Negotiated Decision Notice

Application No:	MCU/12/0017
Street Address:	936 Tinaroo Creek Road, Mareeba
Real Property Description:	Lot 358 on OL451
Planning Scheme:	Mareeba Shire Council Planning Scheme 2016

Type of Approval:	Development Permit for Material Change of Use – High Impact Industry (Concrete Batching Plant) (Formerly Defined as Industry)
-------------------	---

936 Tinaroo Creek Road, Mareeba
Request for 'Other Change' (MCU/12/0018)

936 Tinaroo Creek Road, Mareeba
Request for 'Other Change' (MCU/12/0018)
TRAFFIC IMPACT REVIEW

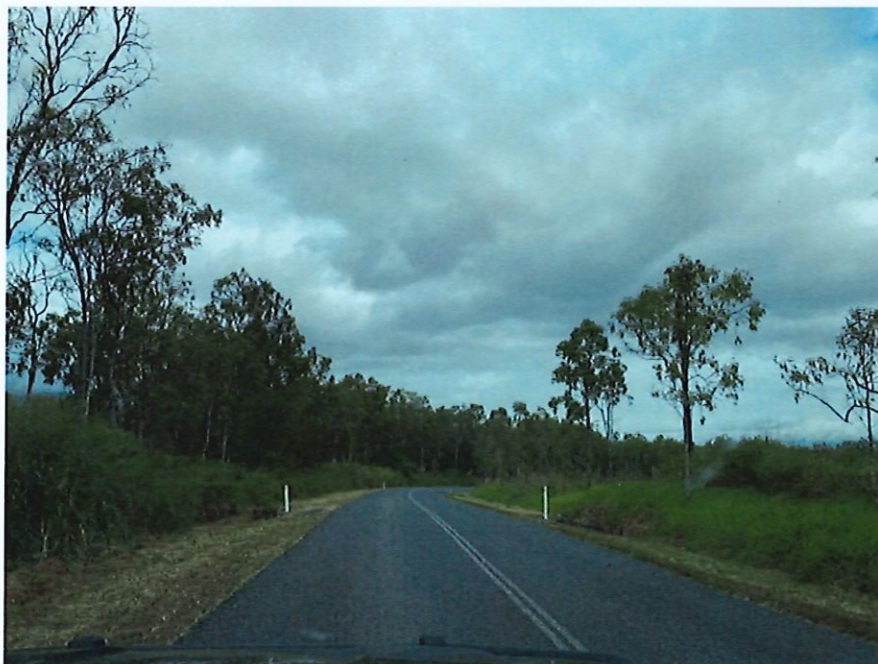
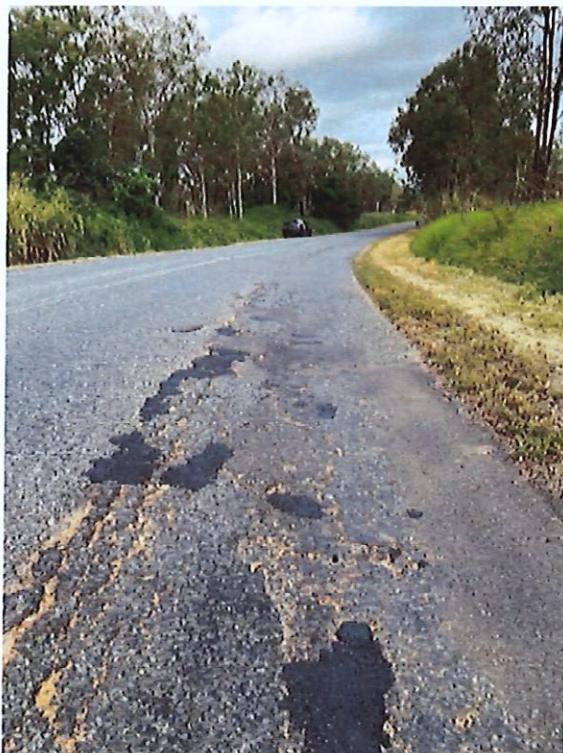
The photos show examples of key locations where sightlines were restricted due to tight bends and crests. As detailed in the report there are a number of locations which could benefit from an assessment of the geometry to ensure pavement width and warning signage is in accordance with relevant standards.

Included are also photos of some examples where there is evident pavement damage, primarily on the bends where heavy vehicles regularly turn. It is acknowledged that these defects are not solely attributed to the traffic generated by the concrete plant, however it is reasonable to assume that the unauthorised level of traffic associated with its operations could have had some level of contribution to the deterioration of the pavement at these locations.
